**Village of Hobart**

**MEETING NOTICE – SITE REVIEW COMMITTEE**

**5. DISCUSSION AND ACTION - New 2,760 square foot commercial building and associated site improvements (Cyrus Dr., Portion of HB-194) (Page 4)**

**6. DISCUSSION AND ACTION - New 2,950 square foot Clubhouse Building and a 784 Square Foot Mail Room/Garage and associated site improvements (Lear Ln., Portion of HB-L159-2) (Page 21)**

GRADING PLAN  
ARVADA CLUBHOUSE  
File: M-21003 Clubhouse Area 100923.dwg

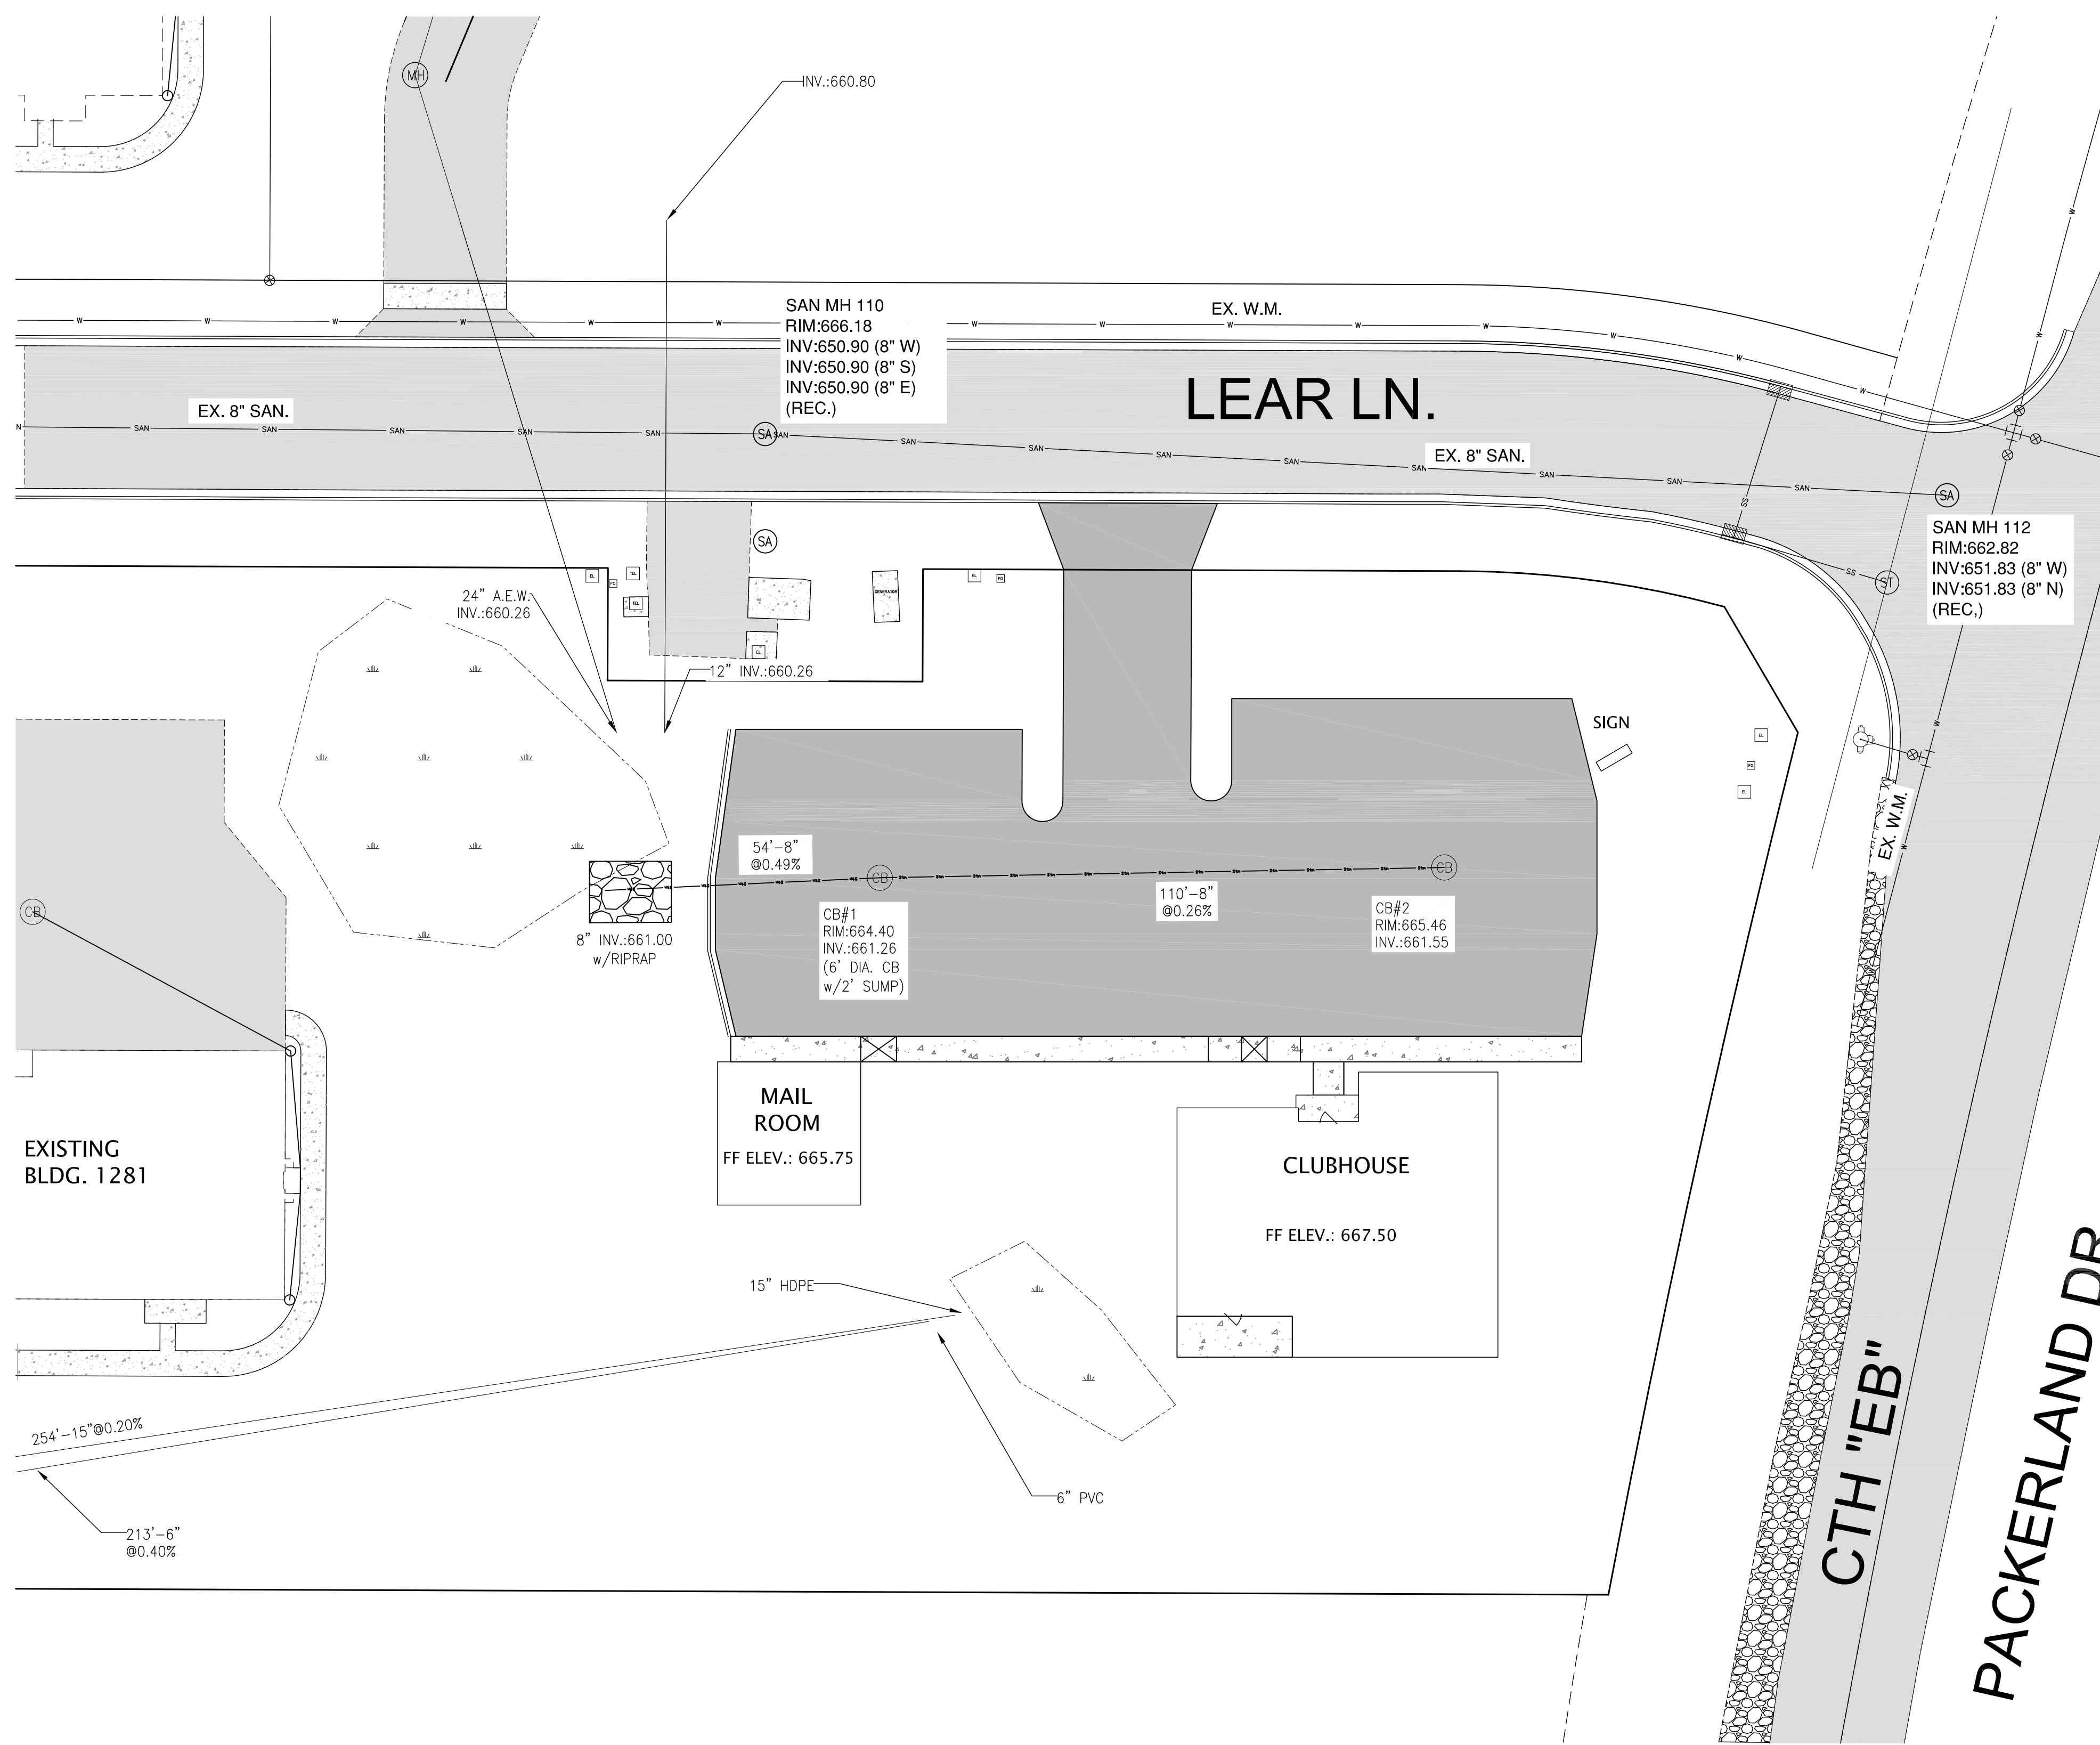
- F. **Storm Water:** Storm water is proposed to be collected by two oversized catch basins in the parking lot and discharge to low area on site. The drainage plan will need to be reviewed and approved by Village Staff and Village Engineer prior to implementation.

1. Storm water drainage plan shall be reviewed and approved by Village Staff and Village Engineer prior to implementation.
2. Landscape plan shall be better detailed and submitted for review and approval prior to implementation. Additional landscaping shall be required to buffer the view of proposed buildings to the residential property to the south.
3. Both the lighting plan and specs on building mounted lighting shall be submitted for review and approval prior to installation.
4. Signage details shall be submitted for approval prior to installation.
5. Screening of any proposed roof mounted HVAC equipment with materials similar to those utilized for the principal building, or landscaping if such equipment is located on the ground.
